Access Compliance Report

Public Rights-of-Way

(Curb Ramps)

Intersection ID: 27658	Main Street: GUNPOWDER_POINT_DR	Cross Street: W_S_LEE_CT	Location:	S
ADA ID: 8230C2272876	Ramp Type: Perp	Initial Pass/Fail: Fail	Overall Compliance: No	Severity Score: 12.5
Codes/Mitigation Info/Possible Solution		Field Measurements/Component Compliance

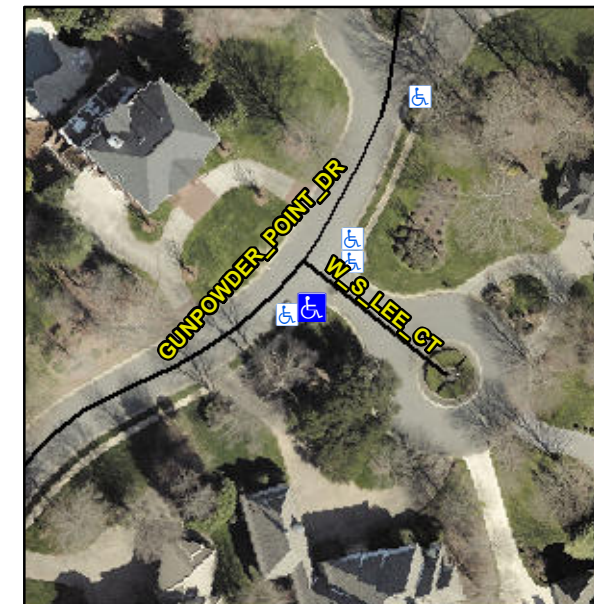
Not Found, R304.2.2

Compliance	Description	Data	Compliance	Description	Data
N/A	Ramp Length (in)	45.0	No	Ramp Slope (%)	10.3
Yes	Ramp Width (in)	54.0	Yes	Ramp XSlope (%)	0.5
N/A	Flare Type LT	N/A	N/A	Flare Type RT	N/A
N/A	Flare Slope LT (%)	N/A	N/A	Flare Slope RT (%)	N/A
N/A	Flare Traversable LT?	N/A	N/A	Flare Traversable RT?	N/A
N/A	Landing Length (in)	N/A	N/A	DWS Provided?	N/A
N/A	Landing Width (in)	N/A	N/A	DWS Contrast?	N/A
N/A	Landing Slope (%)	N/A	N/A	DWS Length (in)	N/A
N/A	Landing X Slope (%)	N/A	N/A	DWS Full Width?	N/A
N/A	Landing Curb? (Y/N)	N/A	N/A	DWS Offset (in)	N/A
N/A	Shared Landing?	N/A			
N/A	Gutter Ponding?	N/A	N/A	Gutter Slope (%)	N/A
N/A	Gutter Lip Ht (in)	N/A	N/A	Gutter X Slope (%)	N/A
N/A	Painted X Walk1?	No	N/A	Painted X Walk2?	N/A
	X Walk 1 Direction	To NE		X Walk 2 Direction	N/A
N/A	X Walk 1 Width (in)	N/A	N/A	X Walk 2 Width (in)	N/A
	X Walk 1 Slope (%)	1.7		X Walk 2 Slope (%)	N/A
	X Walk 1 X Slope (%)	0.7		X Walk 2 X Slope (%)	N/A

Remove & Replace Entire Ramp.
